Falcon Marketplace  
Driveway Permit Resubmittal  
Updated Traffic Impact Analysis  
(LSC #164350)  
October 23, 2017

# Summary of Comments on Microsoft Word - Falcon Marketplace TIA Driveway Permit Update-10-23-17 BOUND REPORT.docx

Figure 5

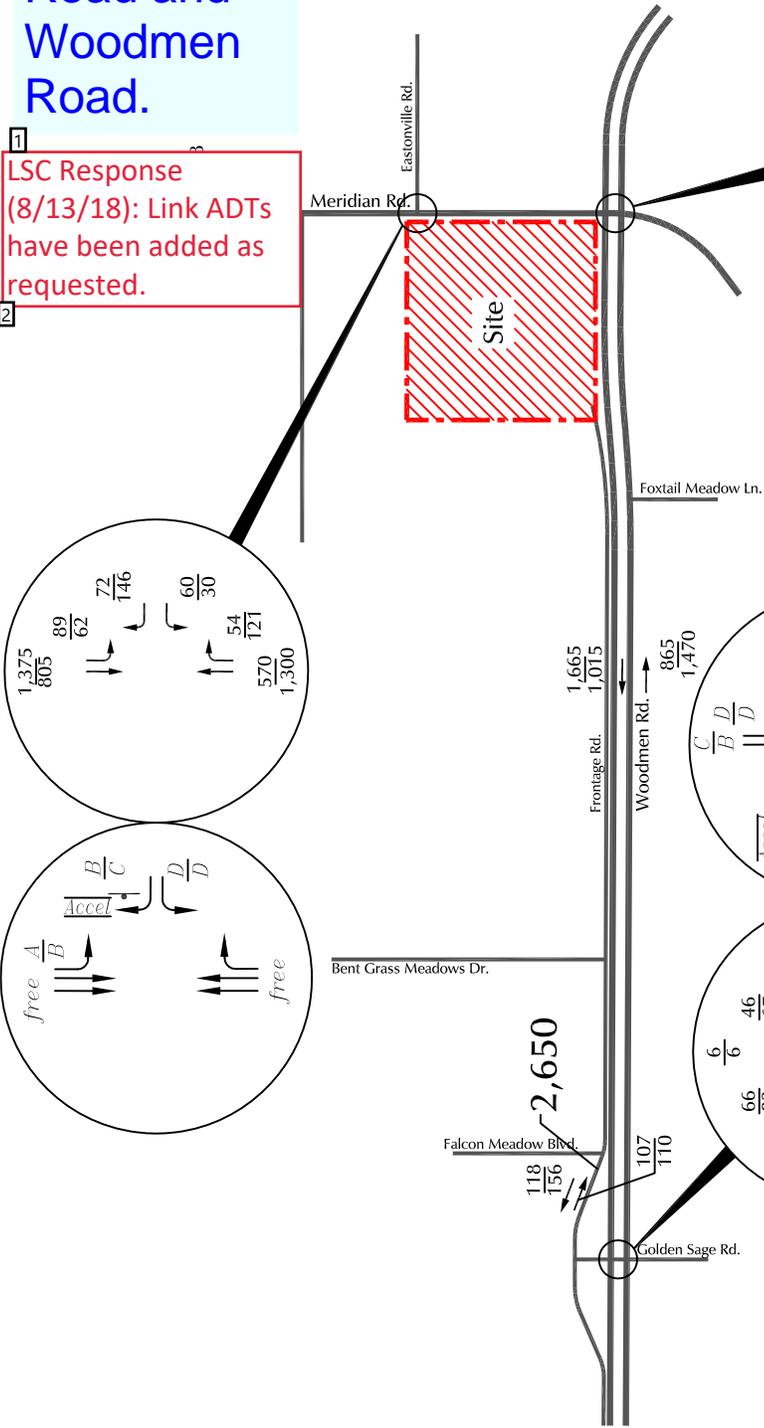
[Provide link ADTs for Meridian Road and Woodmen Road.](#)

LSC Response (8/13/18): Link ADTs have been added as requested.

Figure 6a

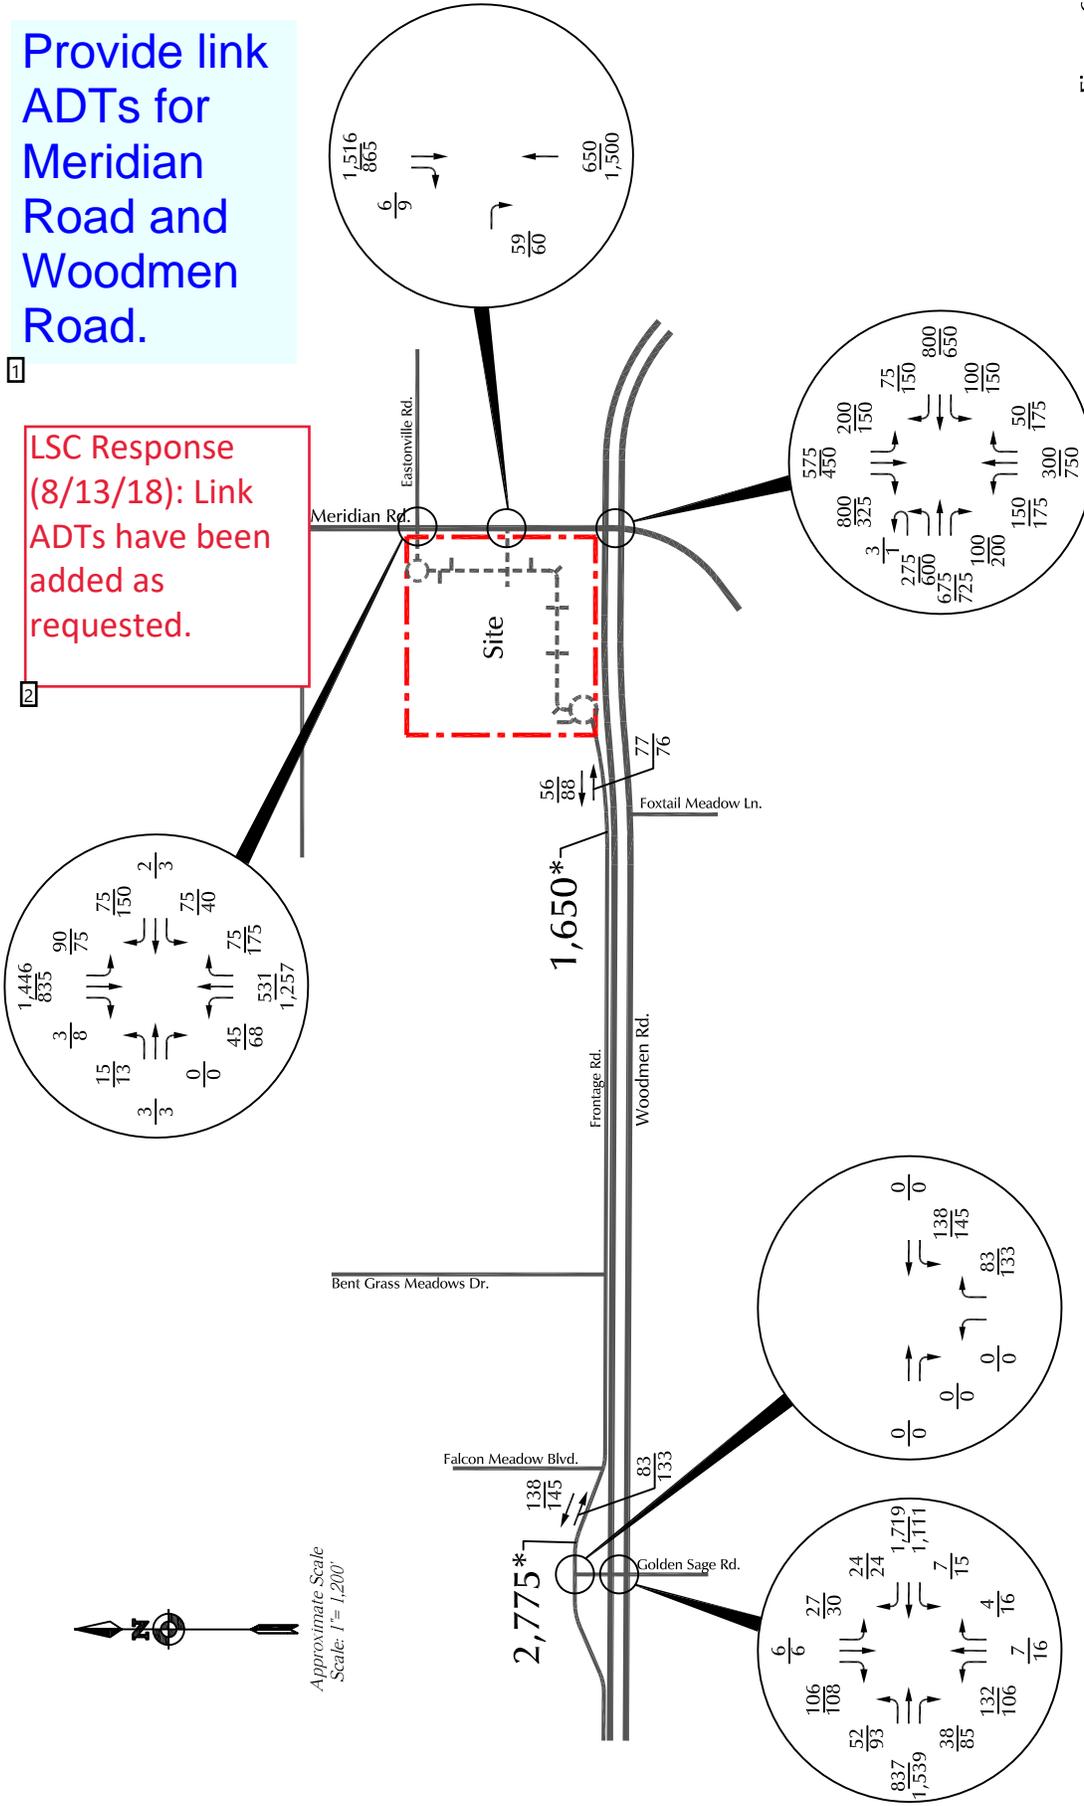
[Provide link ADTs for Meridian Road and Woodmen Road.](#)

LSC Response (8/13/18): Link ADTs have been added as requested.

Figure 1

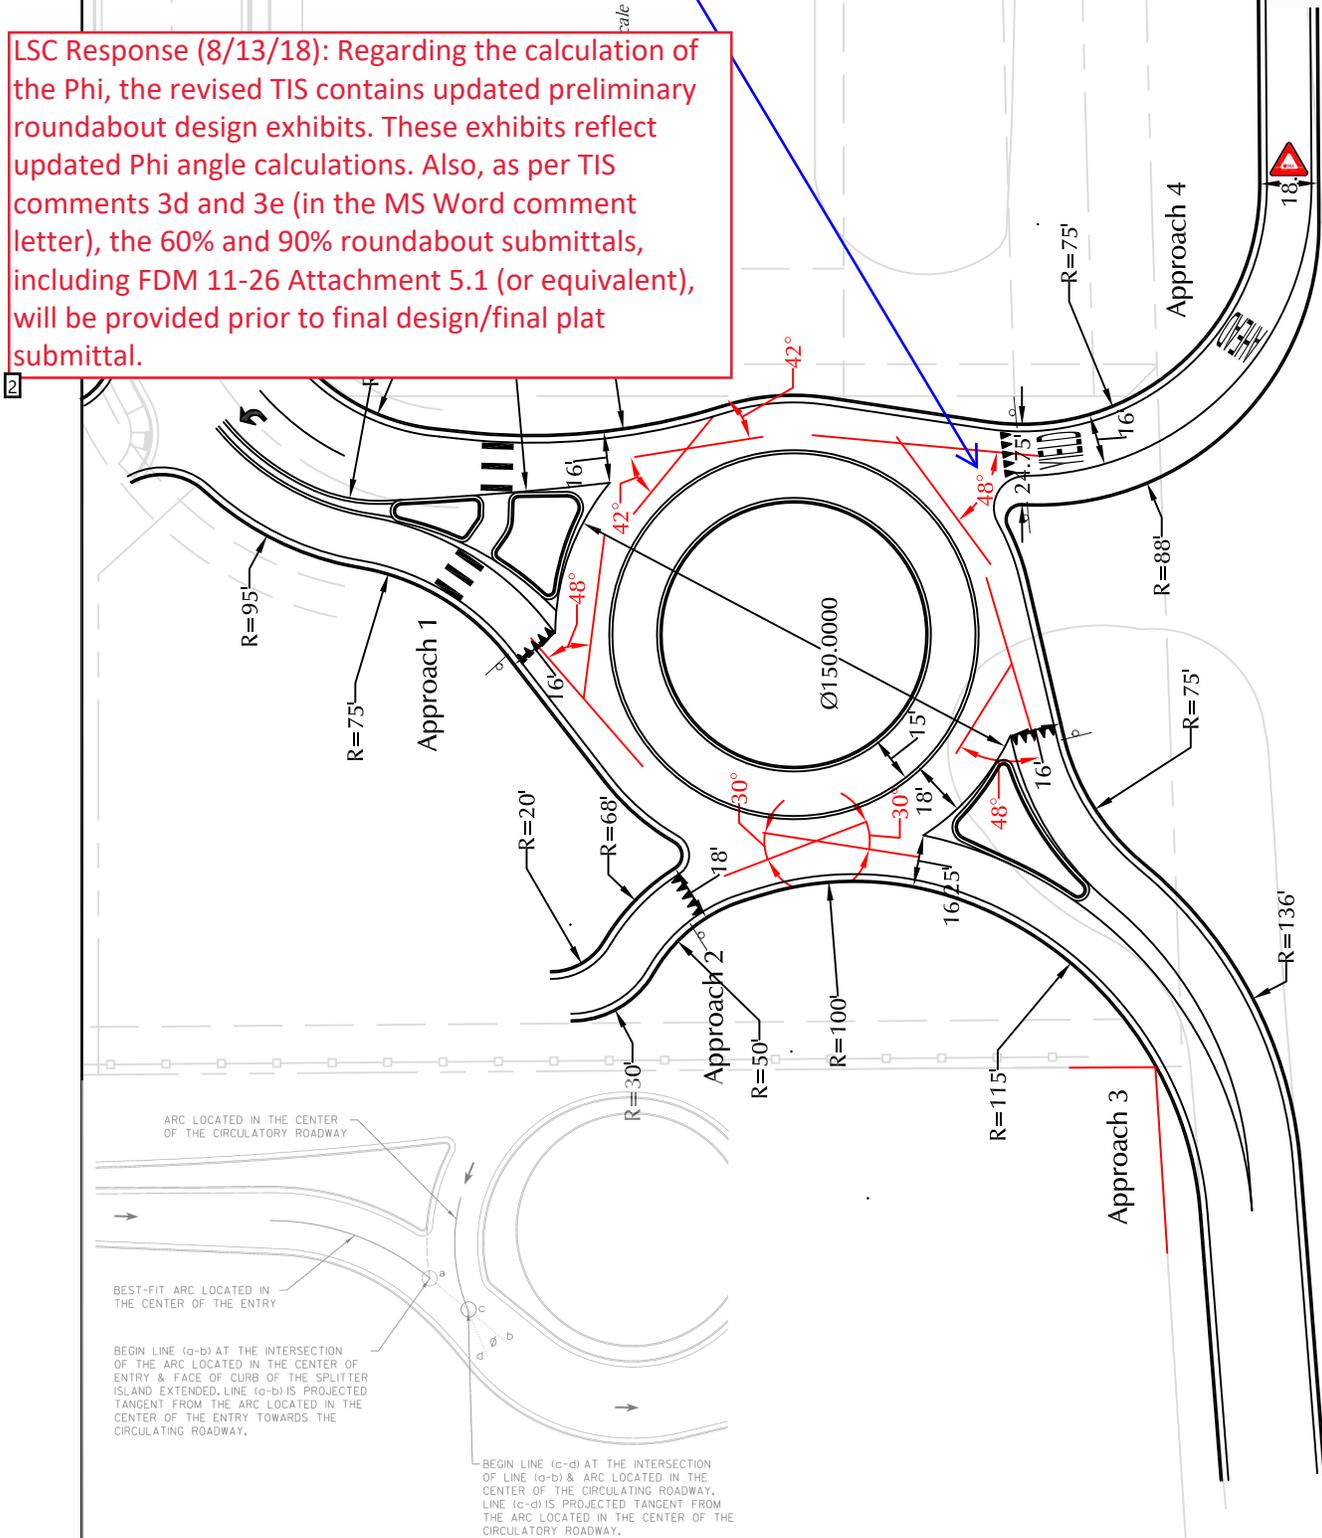
### Calculate Phi per FDM 30.5.23. (see below)

LSC Response (8/13/18): Regarding the calculation of the Phi, the revised TIS contains updated preliminary roundabout design exhibits. These exhibits reflect updated Phi angle calculations. Also, as per TIS comments 3d and 3e (in the MS Word comment letter), the 60% and 90% roundabout submittals, including FDM 11-26 Attachment 5.1 (or equivalent), will be provided prior to final design/final plat submittal.
